Technical Service Bulletin: tsb100239

New Cylinder Head Casting and Valve Rotator

Figure 1 shows the old type valve rotator, figure 2 shows the new type rotator.

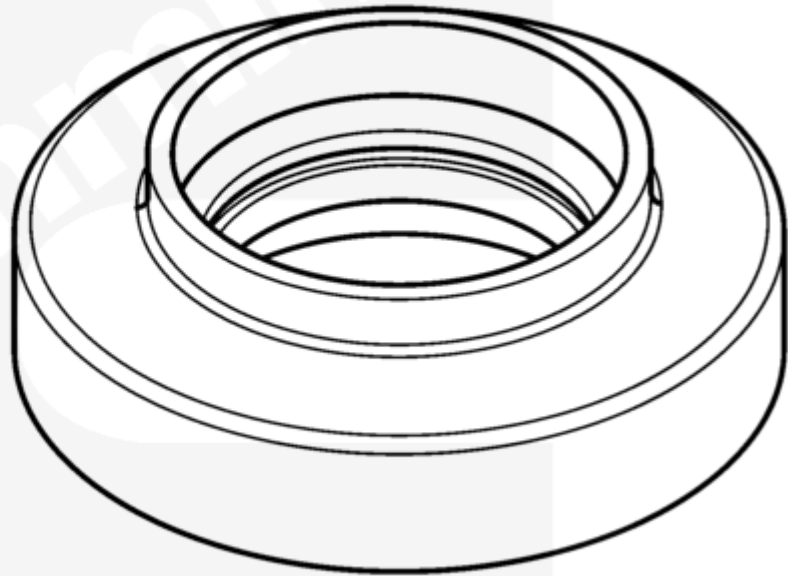
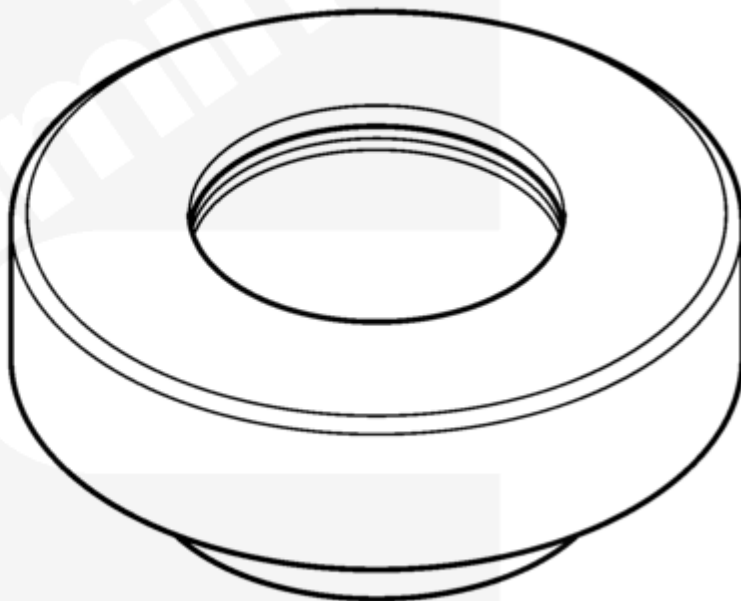
This Technical Service Bulletin introduces changes to the QSK45 and QSK60 cylinder head. A redesigned exhaust gas temperature sensor has led to the exhaust gas temperature sensor port being relocated in the cylinder head. The cylinder head casting has been improved to provide greater resistance to cracking, the casting change can **not** be seen from a visual inspection. The new cylinder head supersedes the existing cylinder head. A new valve rotator has been released for the QSK45 and QSK60 cylinder head, the new valve rotator is a direct replacement for the original.

The original exhaust gas temperature sensor port was located in the top of the cylinder head exhaust port, the new exhaust gas temperature sensor port is located in the side of the exhaust port. The new cylinder head has both the old and new exhaust gas temperature sensor locations and can be fitted to existing engines.

Description	Old Part Number	New Part Number
Cylinder Head	4100537	4086077
Valve Rotator	3085961	4086649
